# PMC for 400 MLD SWRO Desalination Plant at Perur, Chennai

**Sub:** Consultancy for "Design, Preparation of Bid Documents & Evaluation of Bids for the Proposed Construction of 400 MLD Capacity Seawater Reverse Osmosis Desalination Plant at Perur along East Coast Road, South of Chennai, Tamil Nadu and Construction Management & Supervision for the Proposed Desalination Plant and its Product Water Conveyance Pipeline from the Plant and upto Porur and all allied works"

**Action Taken Report / Reply to Queries on the Draft Concept Design Report and Draft Environmental Impact Assessment (EIA) Review Report for CP1 – Reg.**

Fig.1 Recorded Wave level and the Planned Ground Elevation for Proposed Perur DSP

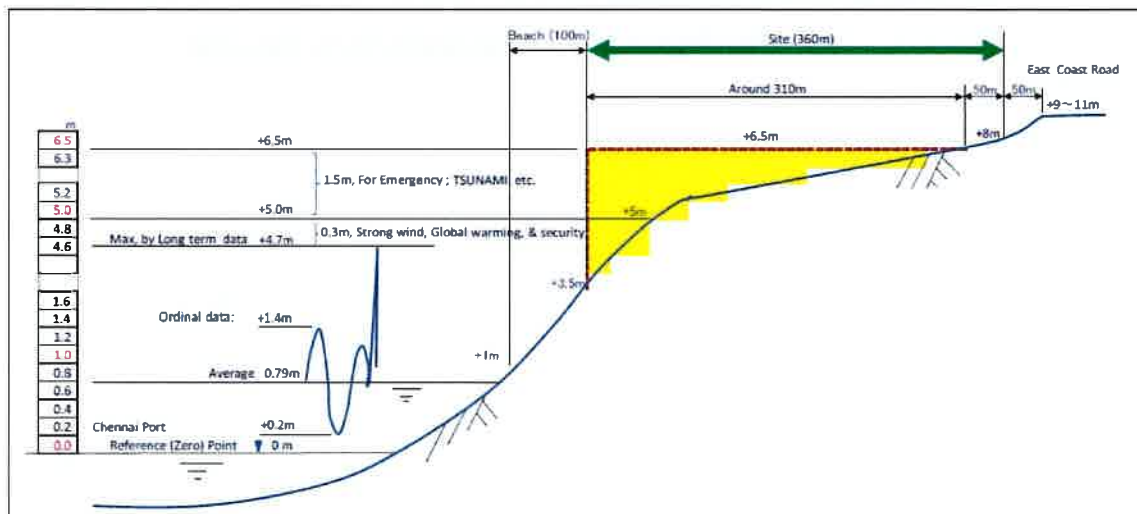
3.	Chart Datum of the project site, the proposed finished floor level with respect to MSL and the additional earth fill required. Accordingly the Annexure II in reference 4 <sup>th</sup> cited may be revised.	<p>The chart datum of the project site has been given in the figures (Attachment II). The ground level profile varies from South side to North side of the project site. In Figure-1 - the profile is expected to be of the Northern side of the project site, where ground level is +3m. Figure 2 shows that the ground level is +2 to 3m in the Southern side while +3m in the Northern side of the project site. All data in the figures are with respect to Chart Datum. The chart datum is 0.65m at the MSL.</p> <p>We will make correction in the Concept Design Report, if there is any discrepancy.</p>

The height of the project site varies between +2 to 3 m CD. Hence it is proposed to raise the site by additional earth fill up to 4.5 m to realize the Finished Ground Level (FGL) of CD +6.5 m. Raising of Finished ground level (FGL) upto +6.5 m CD is warranted to maintain 0.3m safety factor to protect from strong winds and global warming. Also above this 0.3 m, an additional 1.5 m has been considered for Tsunami and other emergency conditions. Please refer Fig. 1 from JICA study report indicating the recorded max wave levels at CD +4.7m plus 0.3m due to strong wind/ global warming and 1.5m due to Tsunami and planned ground level for the proposed Perur DSP at CD +6.5m.
